## SERVICE LETTER 112

### OPTIONAL HYDRAULIC POWER PACK TIMER RELAY INSTALLATION

<b>Aircraft Makes/Model(s):</b>	<b>Float Model(s):</b>	<b>Compliance:</b> Recommended	<b>By:</b> MAS
Aviat Husky, Cessna 170, 172, 175, 180, 182, 185, 206, 208, 208B Piper PA-18, PA-12, American Champion 8GCBC, Pilatus PC-6, DeHavilland DHC-2, DHC-3, Quest Kodiak 100	2100A, 2350A, 3000A, 3450A, 6100A, 7000A, 8000A, 8750A	<b>Part Number:</b> 1005052	<b>Approved:</b> DRH
		<b>Date:</b> 10/11/2023	<b>Revision:</b> G

**CONFIGURATION -01 SINGLE PUMP WIRING SCHEMATIC**  
 (RELAYS SHOWN IN RELAXED CONDITION)

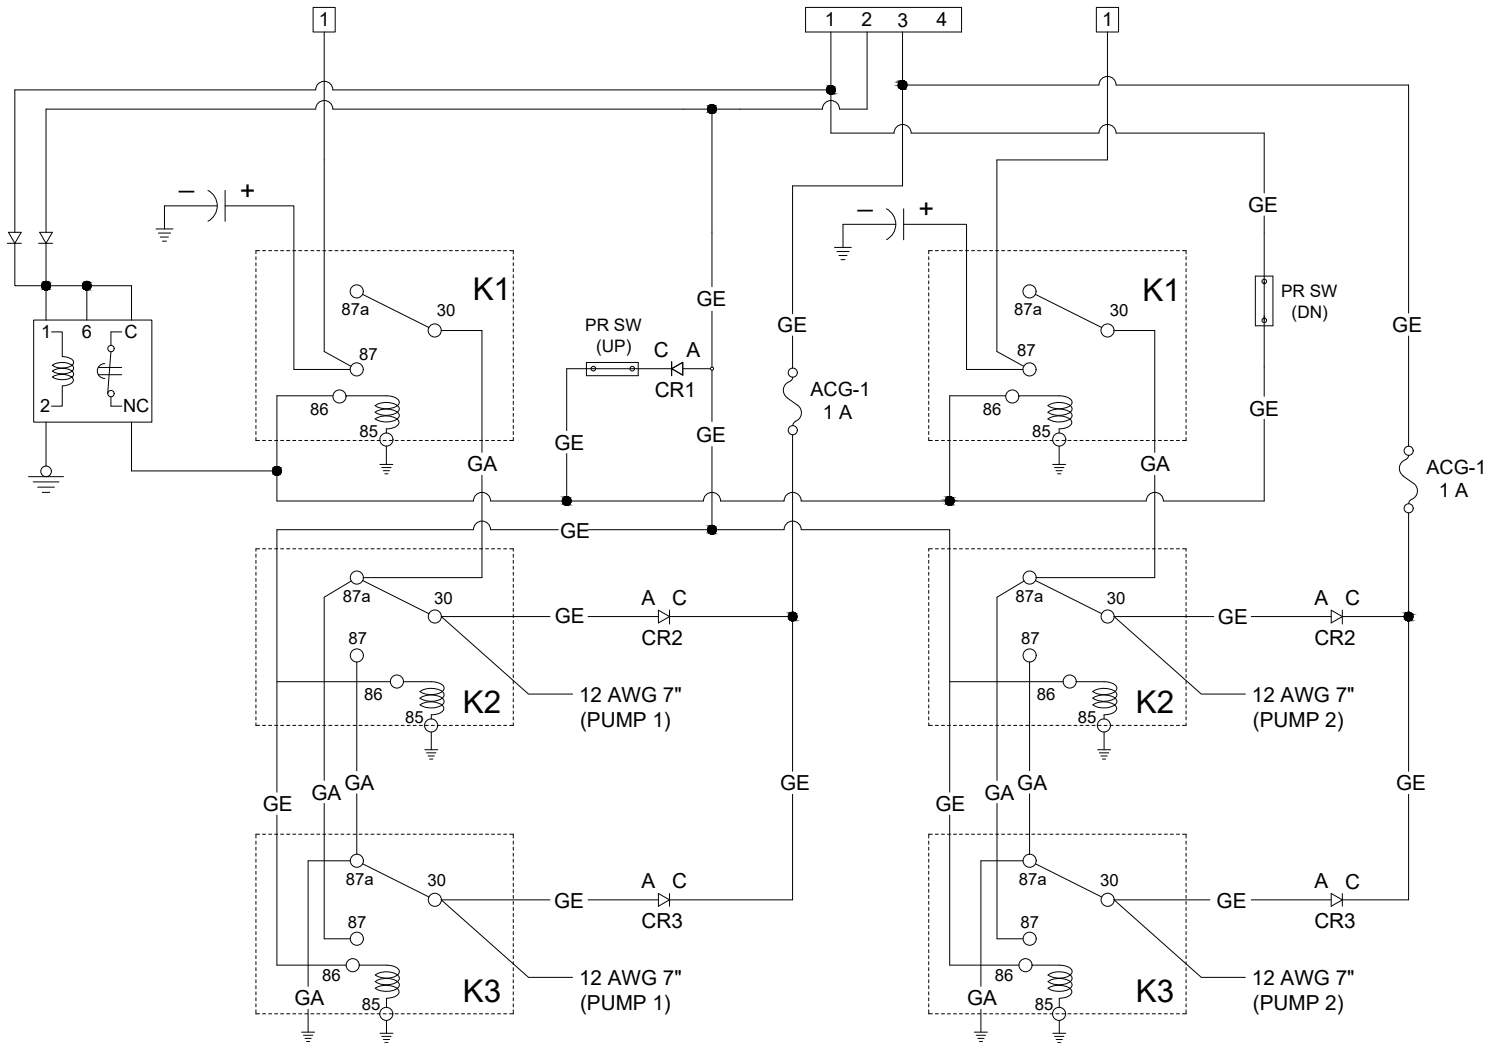
2. Remove backshell from three-wire round plug on pump side of connection.
  - a. Cut back heat shrink 1" from plug end.
  - b. Remove pin 1 from round connector.

- i. Cut off pin and strip insulation back on removed wire and one of the wires coming from terminals 1 and 4 from one of the timer delay relays. (It doesn't matter which relay.)

- ii. Using pin 66099-4 crimp both wires together in the pin and reinstall into pin 1 location in plug.
  - c. Remove pin 2 from round connector.
    - i. Cut off pin and strip insulation back on removed wire and the wire coming from terminals 1 and 4 from the other timer delay relay.

- ii. Using pin 66099-4 crimp both wires together in the pin and reinstall into pin 2 location in plug.
  - d. Reinstall backshell onto three-wire round plug

3. Disconnect two-wire molex plug on down pressure switch. (Down pressure switch is labeled "DN" in the pump casting at the hydraulic fittings.)
  - a. Remove pin 1 from molex housing. (Pin 1 is the pin in the pointed end of plug.)

- i. Cut off pin and strip insulation back on this wire and the wire coming from #3 terminals from the timer delay relay assembly.
    - ii. Using 02-09-1117 crimp both wires together in the pin and reinstall into molex housing pin 1.

- b. Reconnect down pressure switch
4. Connect the wire from #2 terminals from the timer delay relay assembly to ground using MS25036-102 terminal ring or equivalent.
